DRL-2010-002262

Mr. Dane Finerfrock, Executive Secretary
Utah Radiation Control Board
Utah Department of Environmental Quality
168 North 1950 West
P.O. Box 144810
Salt Lake City, UT 84114-4810

Re: Renewal Application for Radioactive Materials License (RML) No. UT1900479; Health Physics Interrogatories -- Round 3; and Engineering Comment Interrogatories -- Round 2

Denison Mines (USA) Corp.		DENISON MINES	
Project: WHITE MESA MILL			
Date: 6-30-00		County: San Juan State: Utah	
By: DLS		Location:	
10-30-09 DLS		FIGURE A-2.2.4-1 SEDIMENTATION BASIN DETAIL	
2-10-10 DLS			
Author: unknown		Drafted By: D.Sleidd

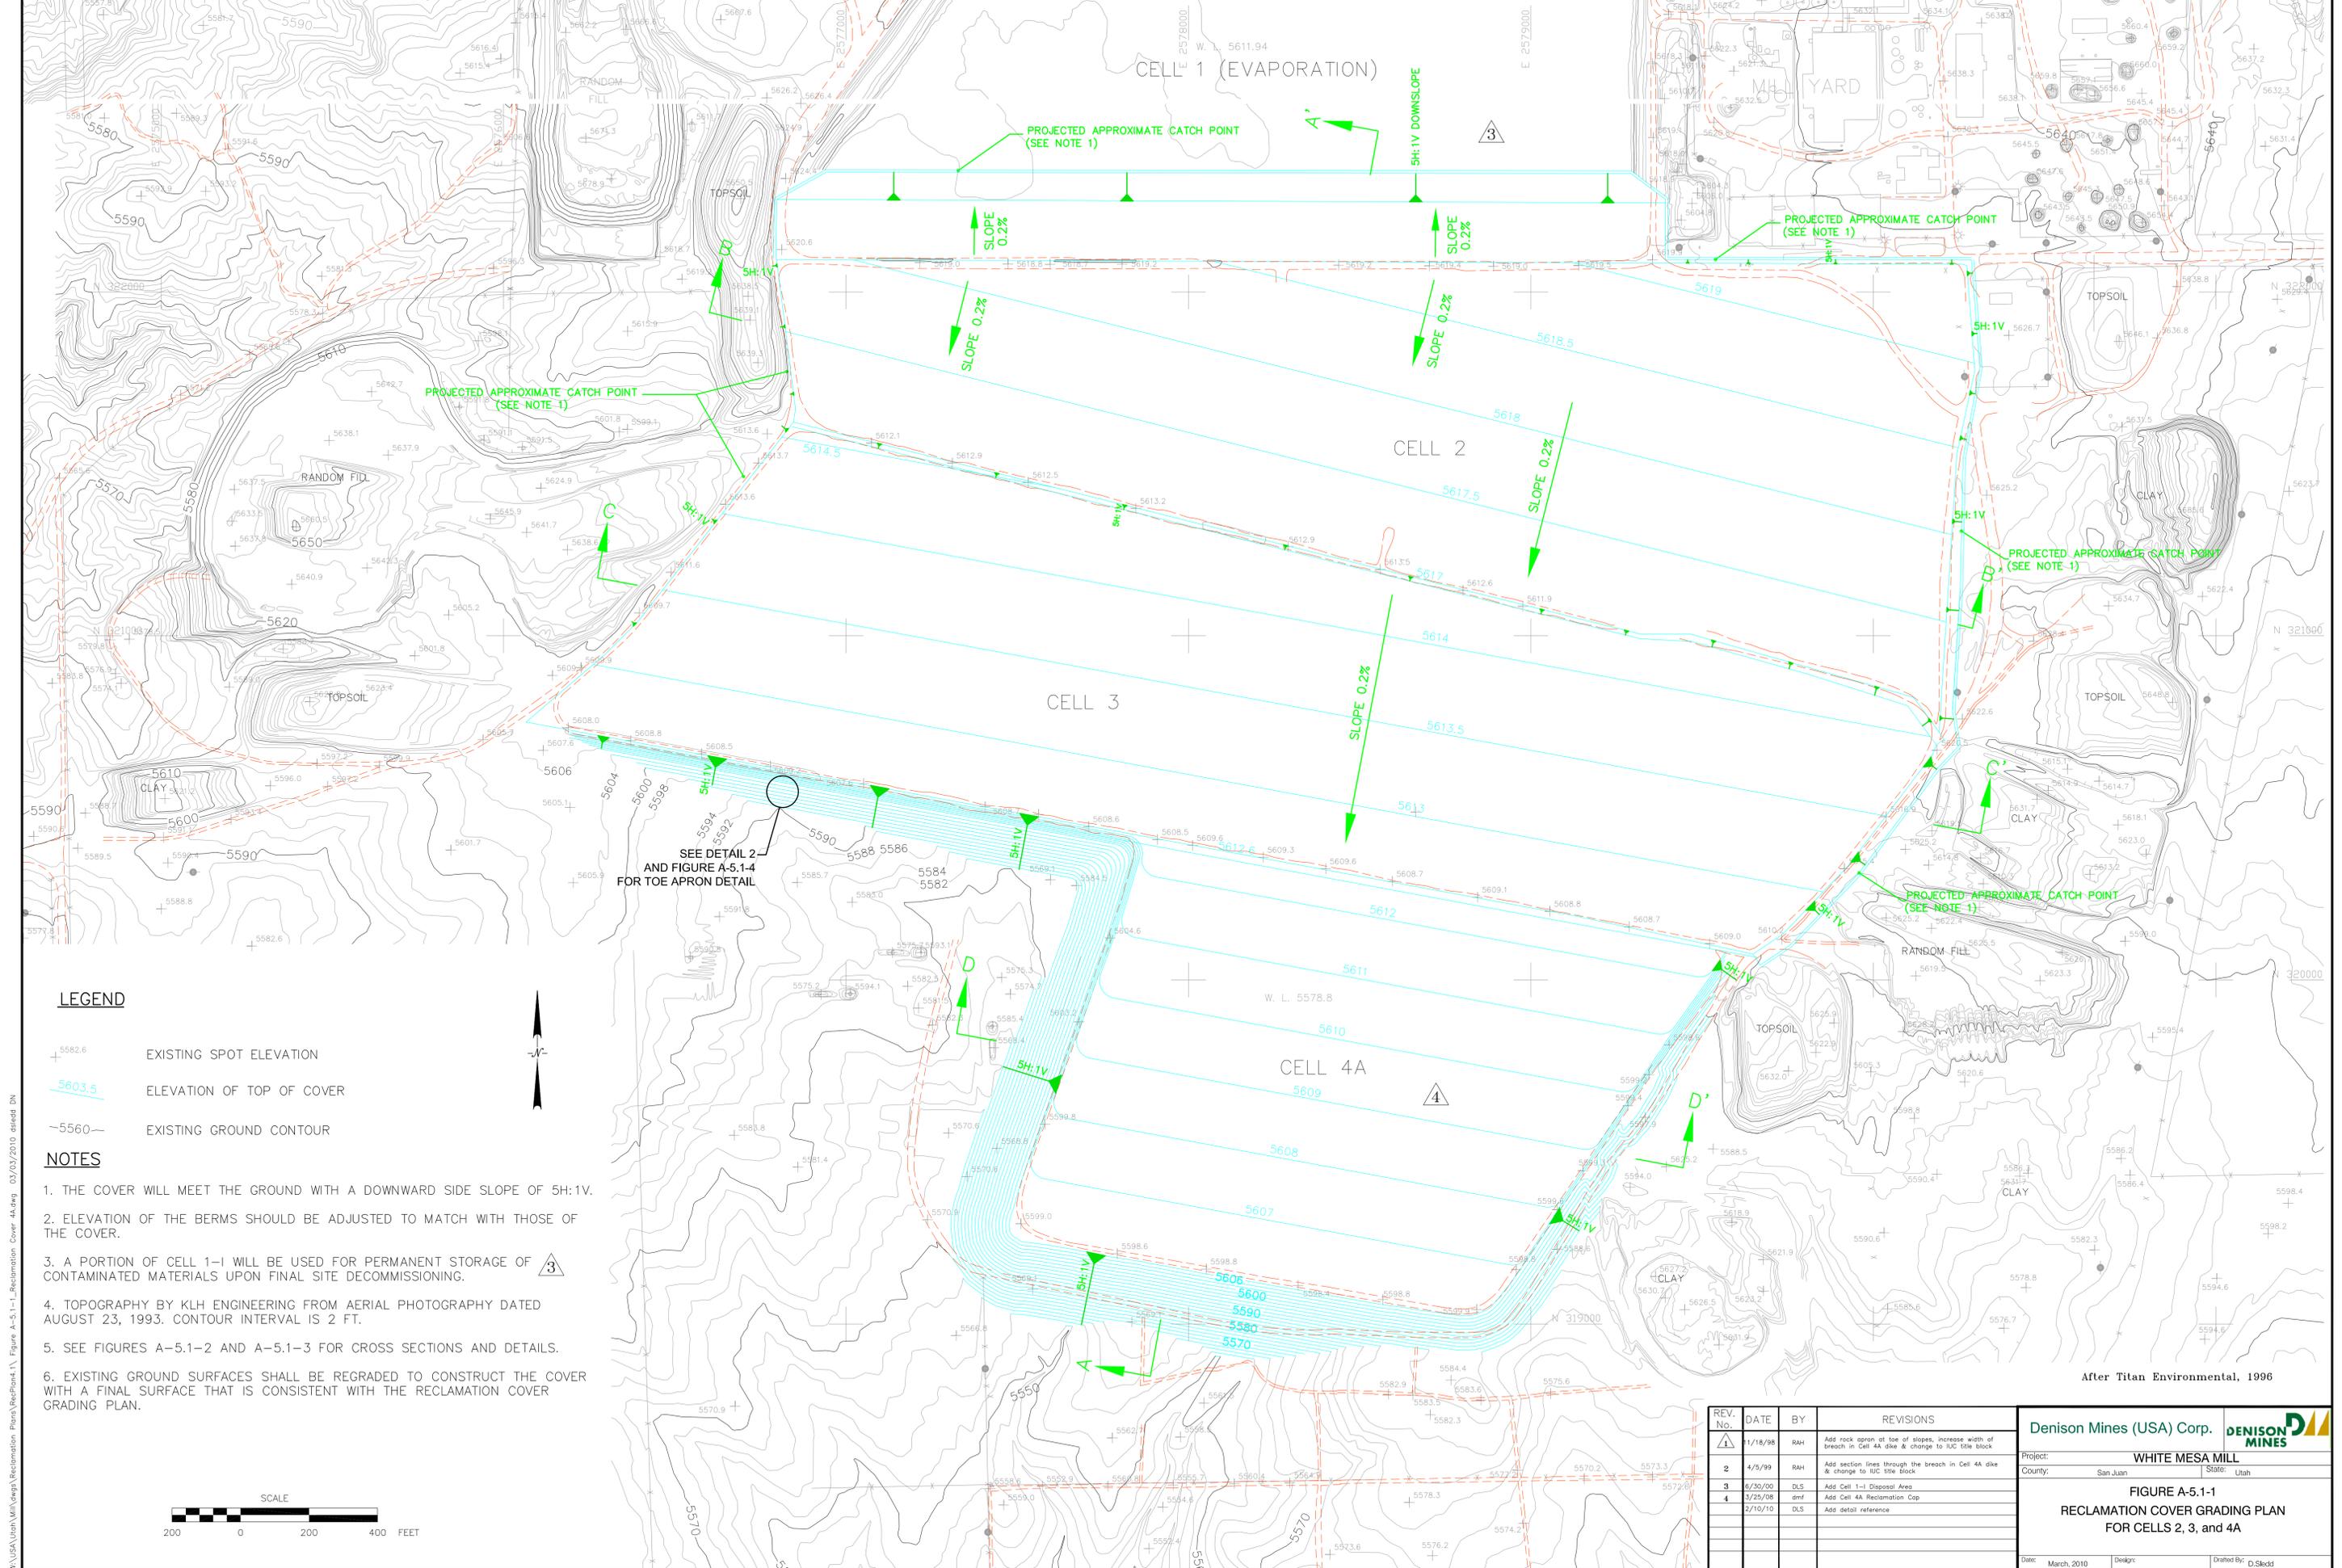
The dimensions shown on the Reclamation Plan drawings for the Cell 1 outlet channel need to be corrected to indicate the dimensions discussed by DUSA above. The Reclamation Plan drawings currently show a 200-foot wide channel bottom. In contrast, your August 14, 2009 response said it would be 150-foot wide.

Please submit revised calculations (above) and corrected drawings of the channel dimensions with plans and specifications for the rip-rap entry apron provision mentioned above for revision to the current Reclamation Plan Version 4.0. This change will need to be included as part of this License Renewal Application.

The dimensions of the discharge channel have been revised on Figure No. A-2.2.4-1 of Revision 4.0 of the Reclamation Plan, to show the discharge channel as 150 feet wide. The revised Figure is included as Attachment B to this letter. The two accompanying copies of the revised Figure are to be inserted as replacement Figures into the two copies of Revision 4.0 of the Reclamation Plan that were previously provided to the Executive Secretary. The calculations for the discharge channel flow are in the existing Attachment G of Revision 4.0 of the Reclamation Plan.

Denison Mines (USA) Corp.		
Project: WHITE MESA MILL		
County: San Juan	State: Utah	
FIGURE A-5.1-1 RECLAMATION COVER GRADING PLAN FOR CELLS 2, 3, and 4A		
Date: March, 2010	Design:	Drafted By: D.Sledd

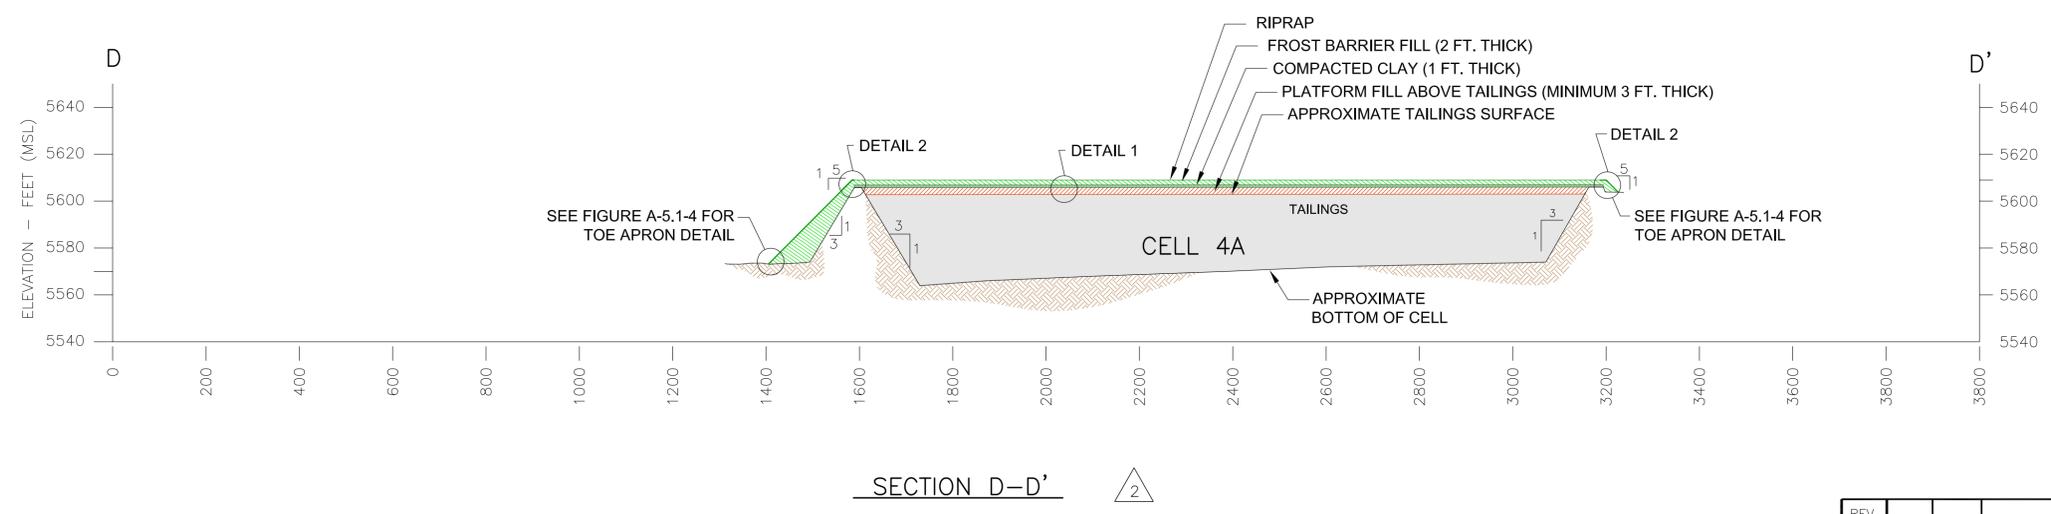
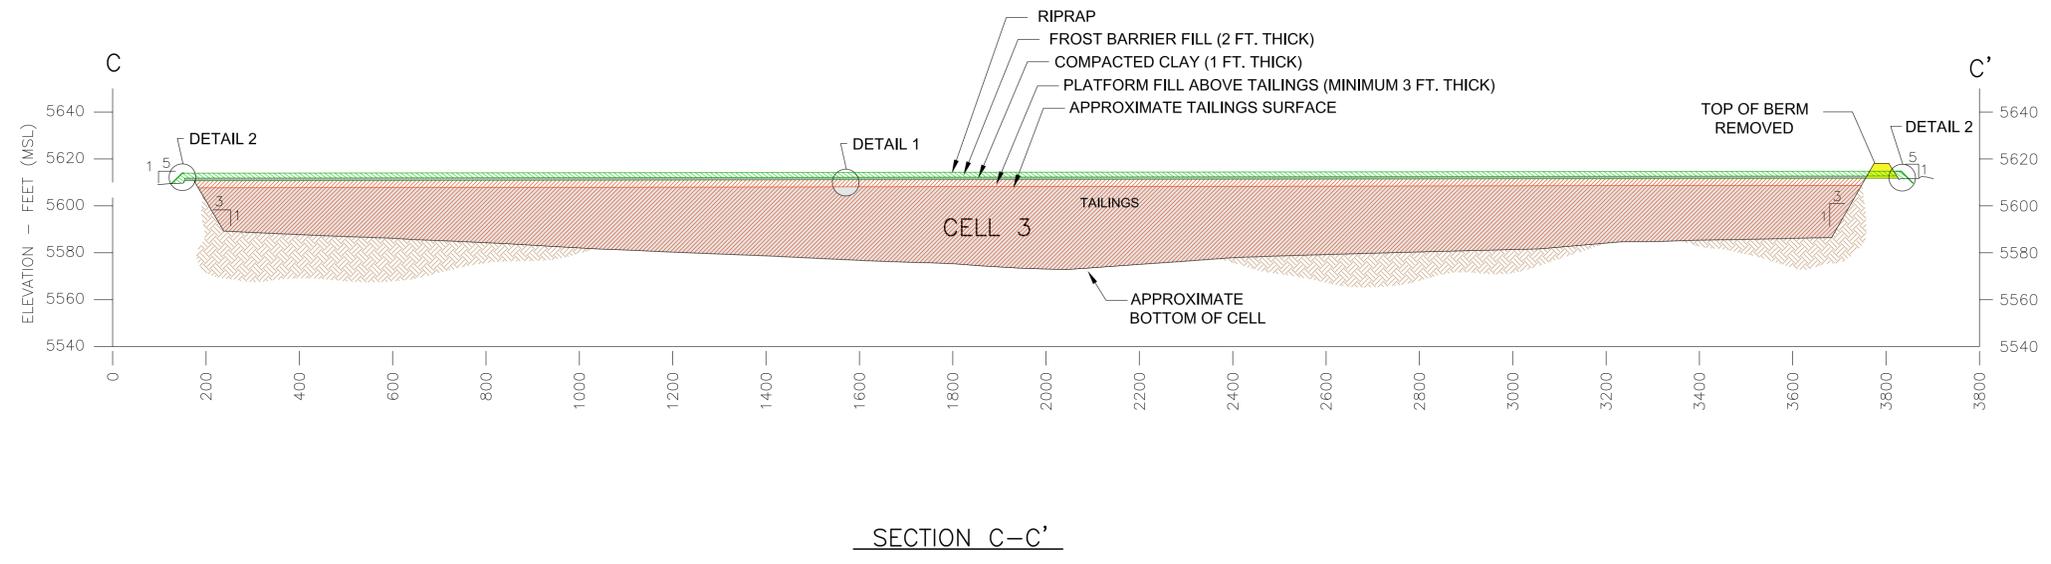
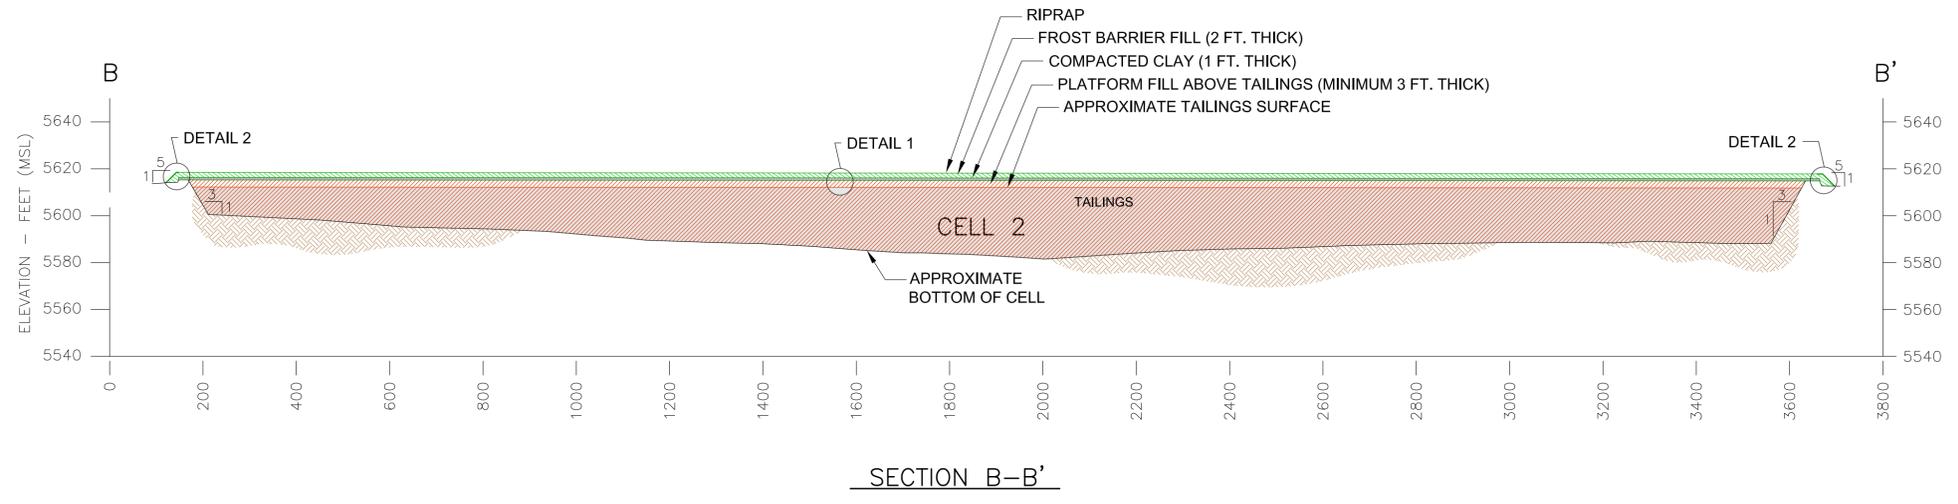
Is installation of a rock apron at the base of all the final covered tailings cell outslope intended for the entire perimeter of the final covered tailings cell system? If so, please clarify by specifying on the drawings that such is required. If not, please demonstrate that the absence of such will be adequate for the 1,000-year design period or at minimum a 200-year period.

The reclamation plan drawings only distinctly specify rock aprons on the south outslope of Cell 4A. It is unclear if installation of a rock apron at the base or toe of all dike outside side slopes is intended. That is, are rock aprons to be installed for the entire perimeter of the tailings cell system? Reclamation Plan figures A-5.1-1, -2, -3 and -4 show a plan view and cross-sections of the tailings cells. The section A-A' on Figure A-5.1-2 on the left side refers to Fig. A-5.1-4, which is a drawing of the "Rock Apron at Base of the Toe of the Cell Outslope." None of these

Figures A-5.1-1, -2, and -3 of Revision 4.0 of the Reclamation Plan have been revised to clarify the requirement for rock aprons to be placed on the 5h:1v outslopes of the reclaimed tailings area. This was the original intent of the reclamation design, and had been included in the estimated costs in Attachment C to revision 4.0 of the Reclamation Plan. These revised Figures are included as Attachment C to this letter. The two accompanying copies of these revised Figures are to be inserted as replacement Figures into the two copies of Revision 4.0 of the Reclamation Plan that were previously provided to the Executive Secretary. The design for the rock apron outslope protection is contained in Attachment G to Revision 4.0 of the Reclamation Plan.

Denison Mines (USA) Corp.			
Project: WHITE MESA MILL			
County: San Juan		State: Utah	
FIGURE A-5.1-3 RECLAMATION COVER DETAILS AND CROSS SECTION			
Date: March, 2010	Design:	Drafted By: D.Sledd

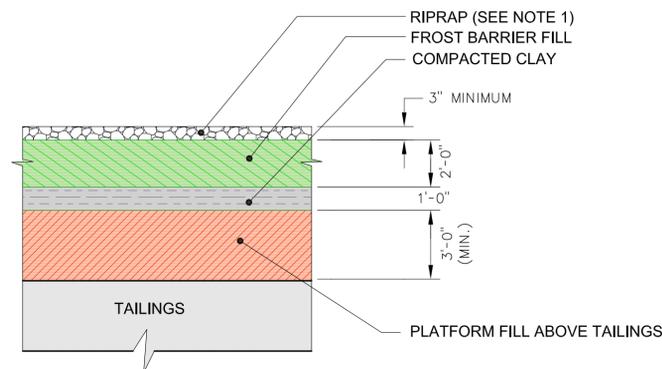
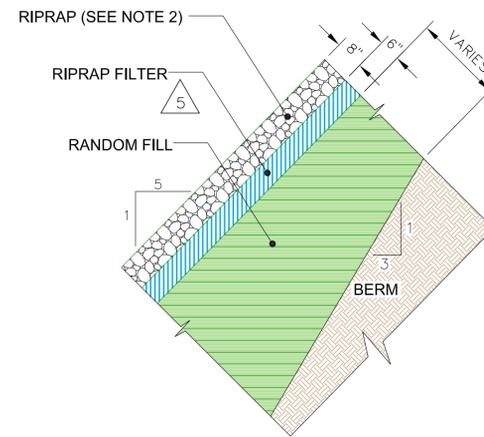
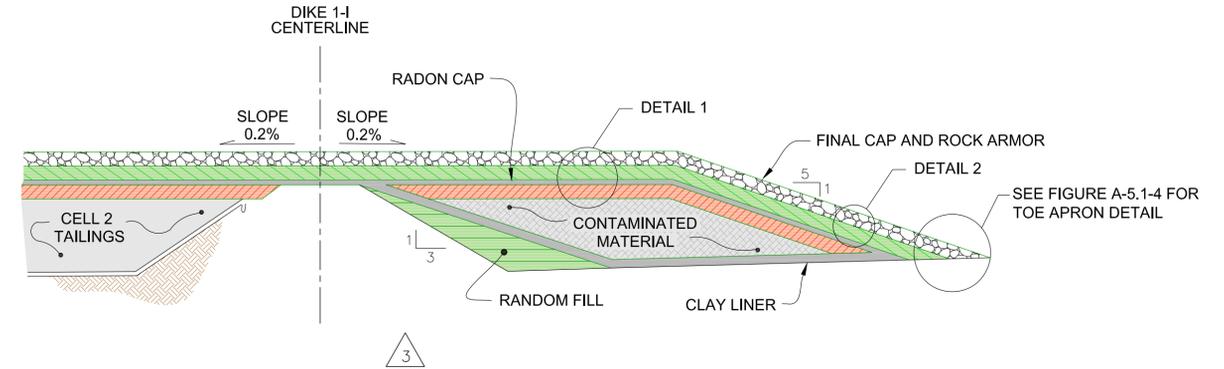
Per Appendix F, Table 1C of the Tailings Cover Design White Mesa Mill 1996, by Titan Environmental Corporation, the minimum D_{50} for the rip-rap diameter for top portion of the cover is to be 3.4 inches.

Drawing A-5.1-3 in the Reclamation Plan Rev 4.0 lists the D_{50} as 0.3 inches. Please correct this error on the drawing.

Figure A-5.1.3 of Revision 4.0 of the Reclamation Plan has been revised to specify a D_{50} of 0.34 inches for the rip-rap diameter for top portion of the cover. This is consistent with Appendix F, Table 1C of the Tailings Cover Design White Mesa Mill 1996, by Titan Environmental Corporation. Revised Figure A-5.1.3 of Revision 4.0 of the Reclamation Plan is included in Attachment C to this letter. The two accompanying copies of the revised Figure are to be inserted as revised Figures into the two copies of Revision 4.0 of the Reclamation Plan previously provided to the Executive Secretary.
